Lack of Power on 2010-2011 Suzuki 2.4L, J24B Engines

The AERA Technical Committee offers the following information regarding a lack of power on 2010-2011 Suzuki 2.4L, J24B engines. The lack of power is associated with long drive extended temperatures during high speed or heavy loaded situations. This condition could be considered an engine problem but this concern involves the automatic transmission.

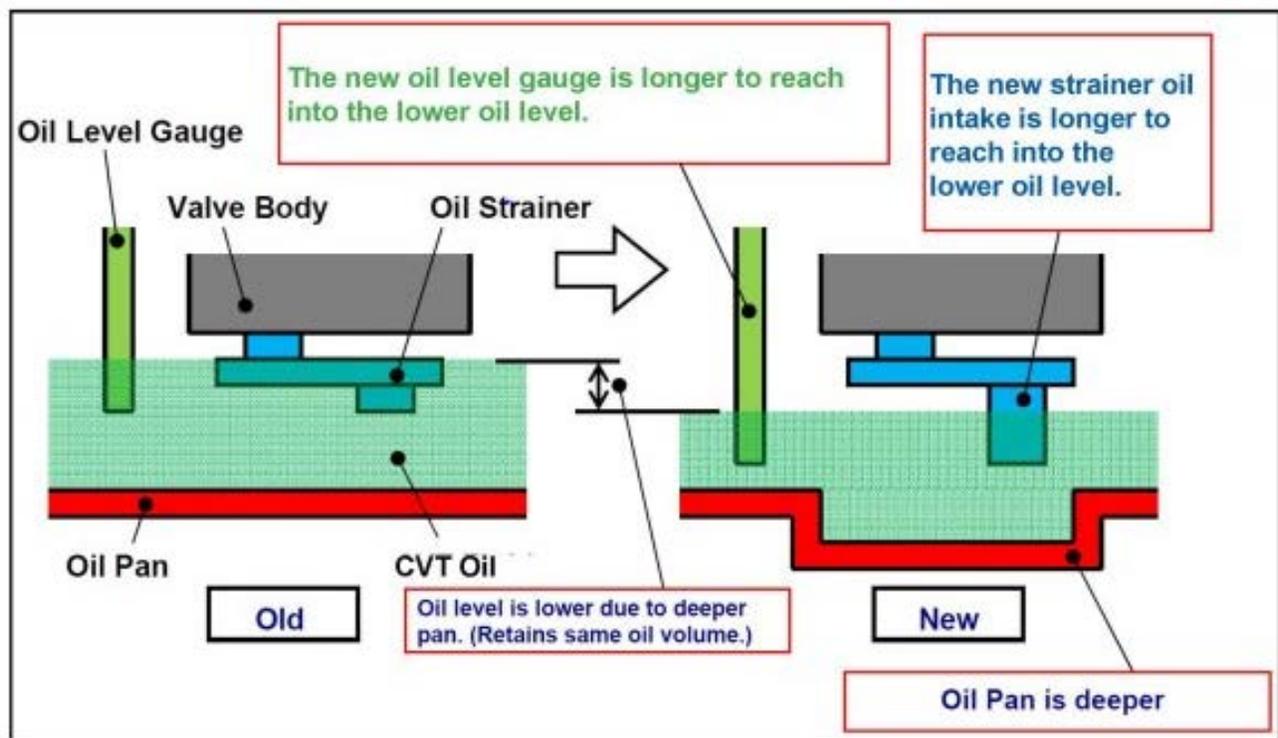
This condition may be caused when the CVT (Continuously Variable Transmission) oil temperatures become extremely high due the high engine loads and the CVT power reduction system becomes active and the engine power is reduced. Design changes to the oil pan have increased oil pan volume and should allow oil temperatures to be maintained much longer than before. Changes were also made to the engine oil level dipstick and oil pickup screen/strainer.

It should be noted that installing the new CVT oil pan without installing the new CVT oil strainer will result in a lack of CVT lubrication and cause CVT damage. When replacing the old oil pan with the new oil pan it is important to install a new oil screen/strainer and new oil level dipstick gauge. Never reuse oil pan bolts, the oil pan gasket or the oil pan gasket once they are removed, replace them with new parts.
